**Subject** ▶ Change on Insulation Washer and Brush Holder Caps

**For Models** ▶ HM1800 (Demolition Hammer)

▶ Current	▶ New
<p>1) Change of Insulation Washer</p> 	 <p>Metal Sleeve</p>
<p>2) Change of Brush Holder Caps</p> 	 <p>Adhesive applied</p>

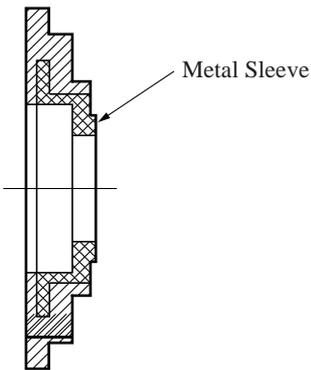
**Description** ▶ Metal Sleeve has been inlaid into Insulation Washer for preventing fan from slipping. Adhesive has been applied on Brush Holder Caps, for preventing loosening.

Item No.	Current part		Q'ty	I/C	New part		Q'ty	Note
5	Insulation Washer 681635-2		1	<=	Insulation Washer 681646-7		1	Current parts may be used to other models
10	Brush Holder Cap 643700-5		2	<=	Brush Holder Cap 643710-2		2

HM1800: From serial No. 8657E
